TITLE: PITCH 2.54mm PIN HEADER DUAL ROW SMT		HOMETOM www.hometom.com.tw	
		HORNG TONG ENTERPRISE CO.,LTD.	
TOLERANCE		APPROVAL:	UNIT: mm
LINEAR: X. ±0.30 .X ±0.25 .XX ±0.20	ANGLE: X° ±2° .X° ±1° .XX° ±0.5°	CHECK:	PART NO: PH**JF***AC74
CUSTOMER DRAWING	REV: B	DRAWN:	SIZE: A4
			DWG.NO: CPH415-00
			SCALE: 2:1
			PRJ.: SHEET: 1/1

深圳市紘通电子有限公司
變更通知(ECN)

特急件 急件 一般件
制程變更 設計變更 其它
 發文部門: 研发部 發行日期: 2016.08.27
 ECN編號: BN16082703

品名	PITCH 2.54mm PIN HEADER DUAL ROW SMT	
料號	PH**JF***AC74	
版次	(A) → (B)	頁數 2
关联文件	<input checked="" type="checkbox"/> 无	<input type="checkbox"/> BOM <input type="checkbox"/> SOP/SIP <input type="checkbox"/> 零件图 <input type="checkbox"/> 其他
變更原因	<input type="checkbox"/> 客戶要求 <input type="checkbox"/> 設計要求 <input type="checkbox"/> 製造要求 <input type="checkbox"/> 降低成本 <input type="checkbox"/> 品質要求 <input type="checkbox"/> 其他	修改載帶寬度

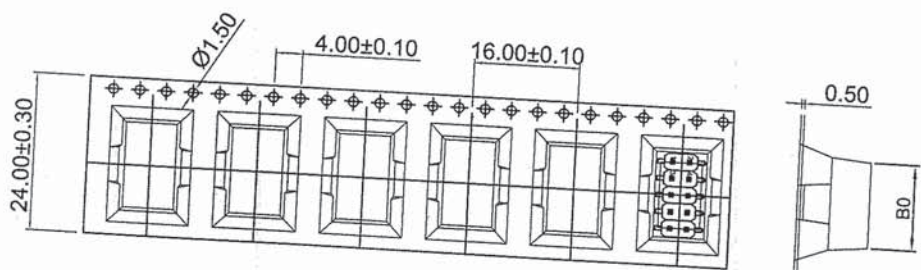
REV.	ECN NO.	DESCRIPTION	DWN.	APVD.	DATE
A	N/A	INITIAL ISSUE	LZQ	DLQ	2016.04.08
B	BN16082703	修改载带宽度	LZQ	DLQ	2016.08.27
